STATE OF CONNECTICUT
CONNECTICUT SITING COUNCIL

IN RE: :
 :
 :
 APPLICATION OF MCF COMMUNICATIONS : DOCKET NO. 358
 bg, INC. AND CELLCO PARTNERSHIP D/B/A :
 VERIZON WIRELESS FOR A CERTIFICATE :
 OF ENVIRONMENTAL COMPATIBILITY :
 AND PUBLIC NEED FOR THE :
 CONSTRUCTION, MAINTENANCE AND :
 OPERATION OF A WIRELESS :
 TELECOMMUNICATIONS FACILITY IN THE :
 TOWN OF THOMPSON, CONNECTICUT : MAY 20, 2008

RESPONSES OF CELLCO PARTNERSHIP D/B/A VERIZON WIRELESS
TO CONNECTICUT SITING COUNCIL PRE-HEARING INTERROGATORIES

2 MILE VIEWSHED ANALYSIS MAP

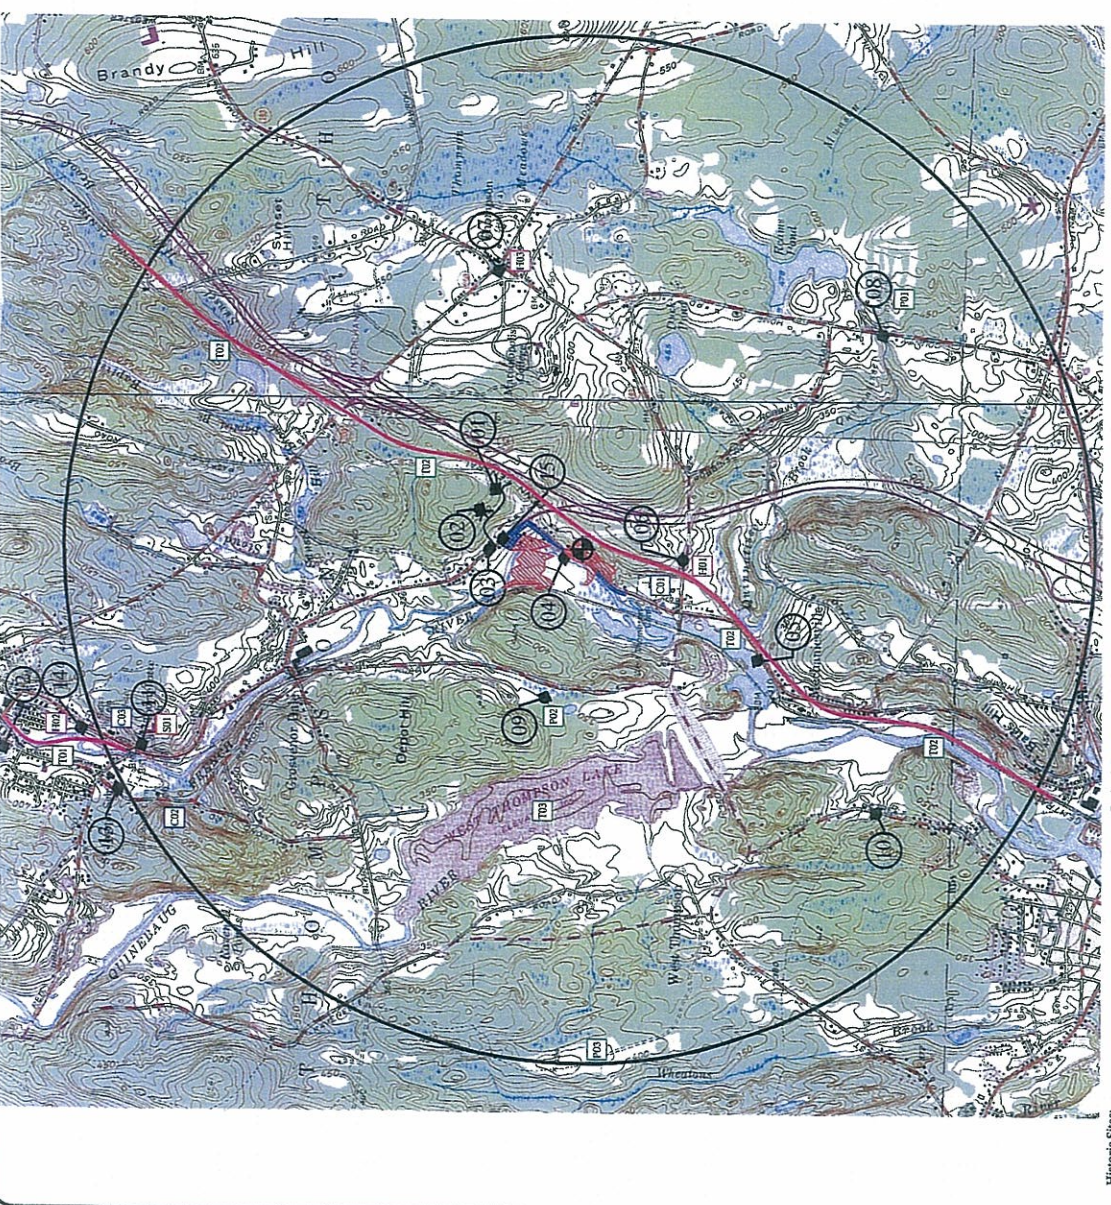
Provide the “2 Mile Viewshed Analysis Map” for proposed Site A and Site B in 11-inch by 17-inch format.

See Attachment 2.

Verizon Wireless: Power Density Evaluation

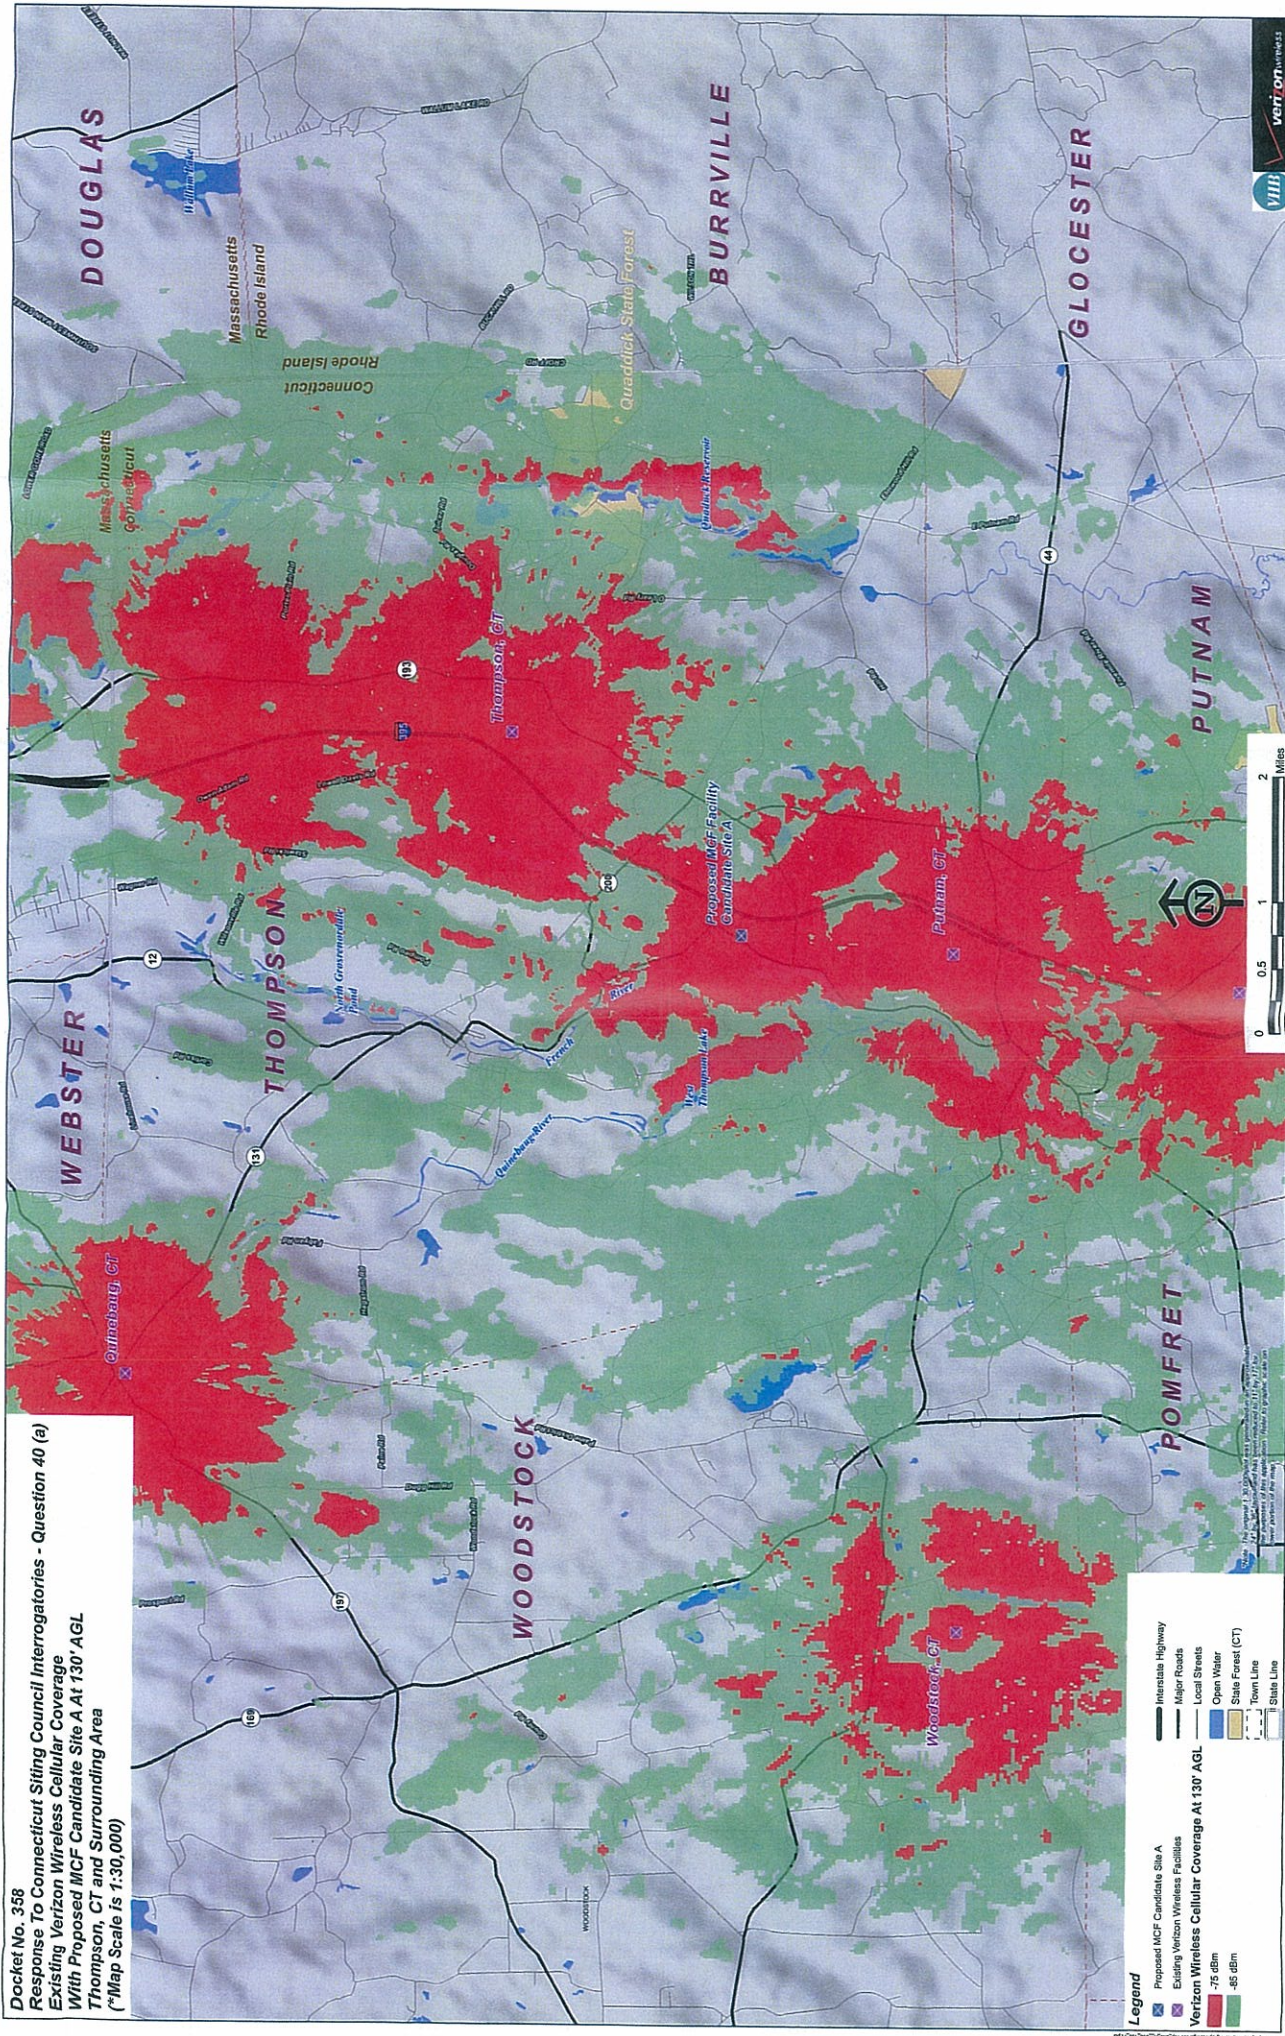
Provide the data and formula used in the calculation of the power density for Cellco antennas at the proposed sites.

The formula used to calculate power density is included in Attachment 4.

Docket No. 358
 Response To Connecticut Siting Council Interrogatories - Question 40 (a)
 Existing Verizon Wireless Cellular Coverage
 With Proposed MCF Candidate Site A At 130' AGL
 Thompson, CT and Surrounding Area
 (Map Scale Is 1:30,000)

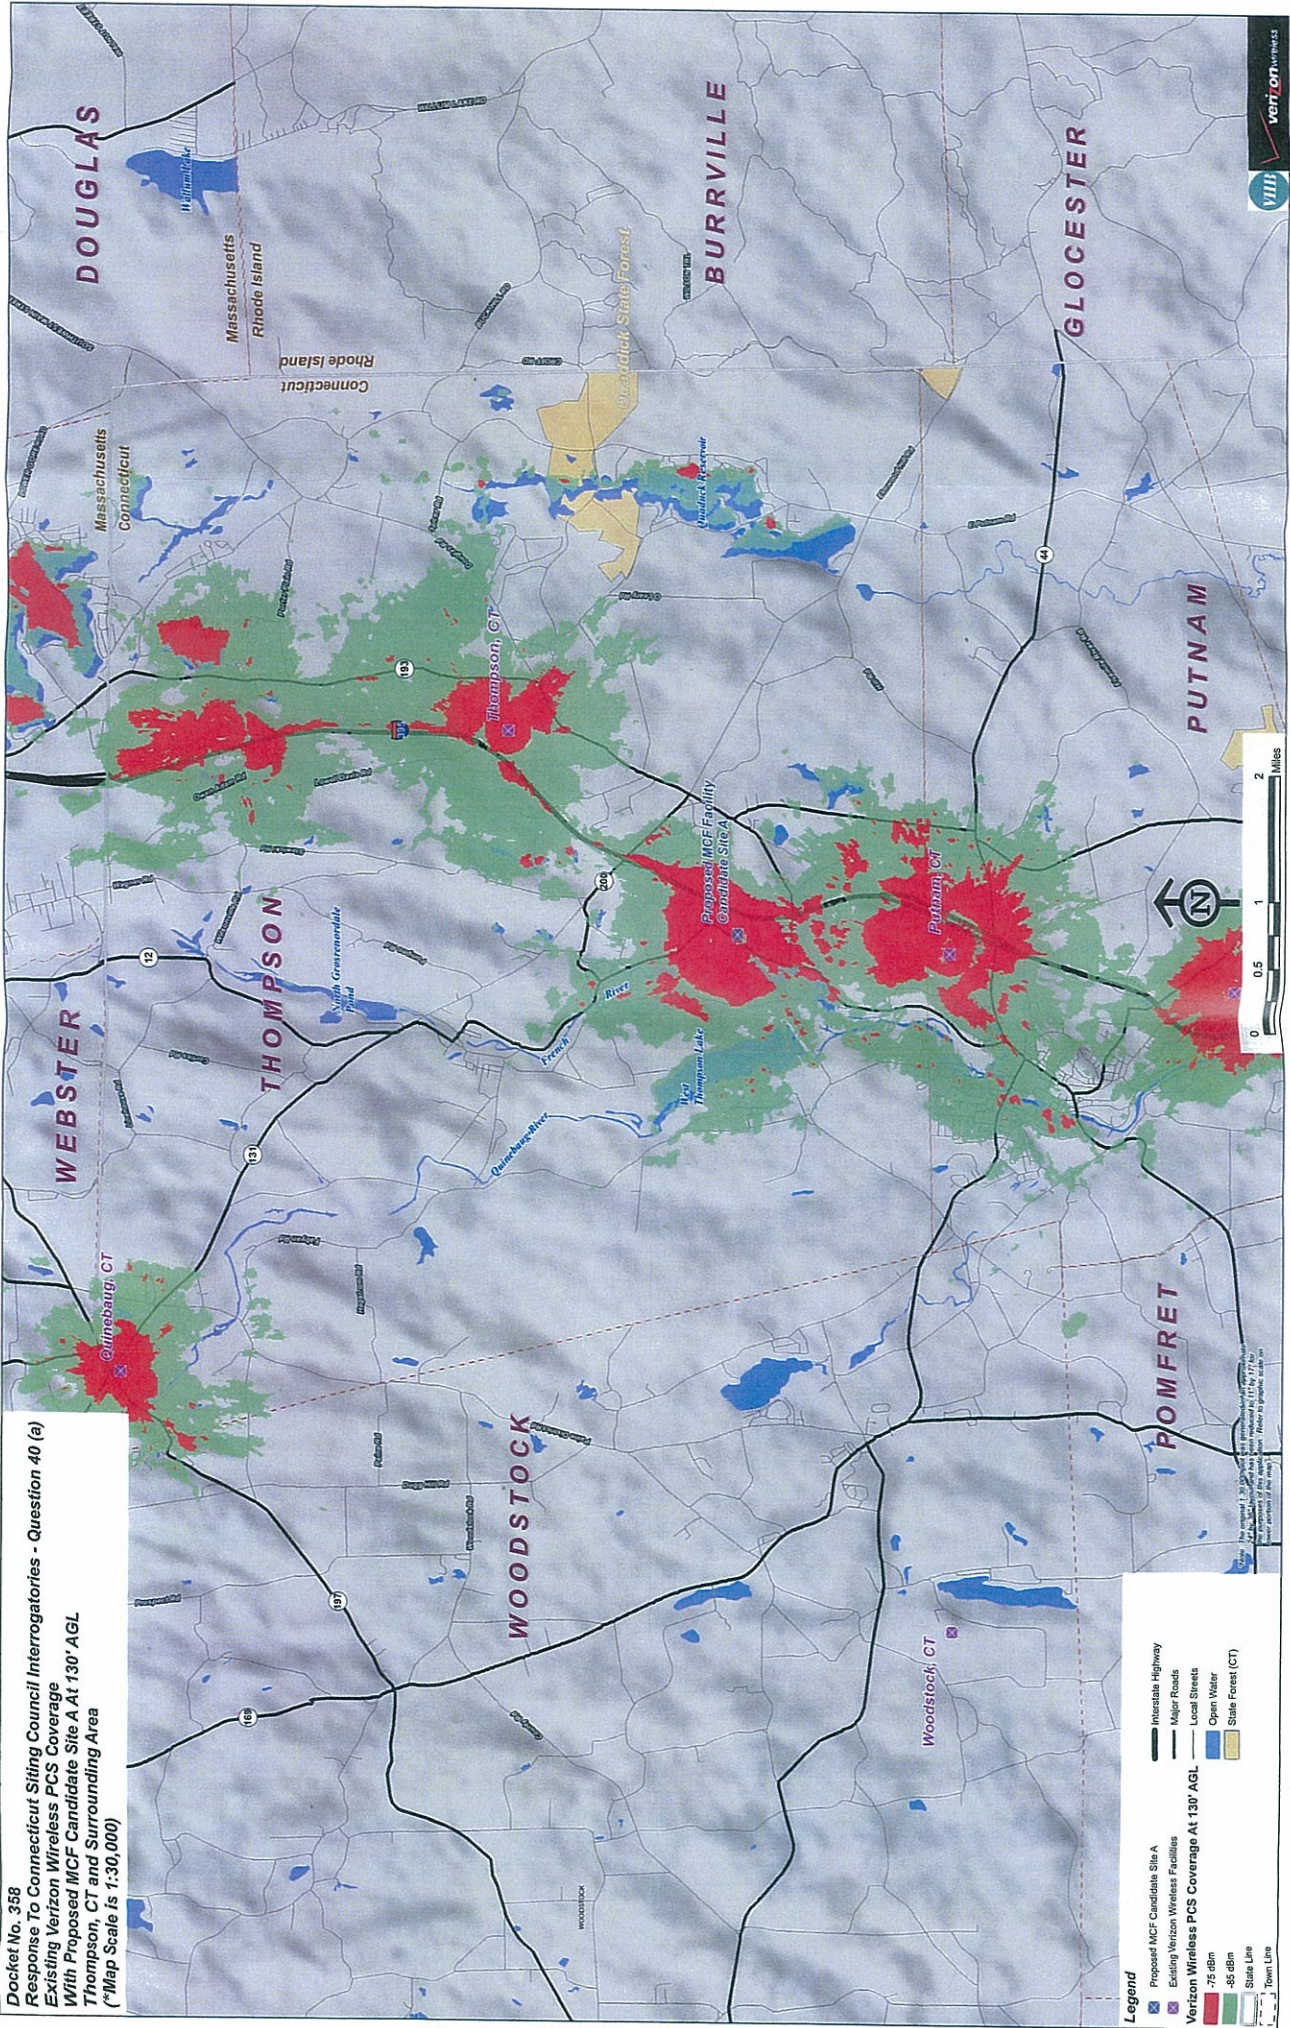
Provide a multi-signal level propagation plot (including the signal levels Cellco designs for), at a scale of 1:30,000, depicting coverage from the following:

- a) existing sites and proposed Site A at an antenna height of 130 feet above ground level.
- b) existing sites and proposed Site A at an antenna height of 120 feet above ground level.
- c) existing sites and proposed Site B at an antenna height of 130 feet above ground level.
- d) existing sites and proposed Site B at an antennas height of 120 feet above ground level.

The coverage plots requested are included in Attachment 5.
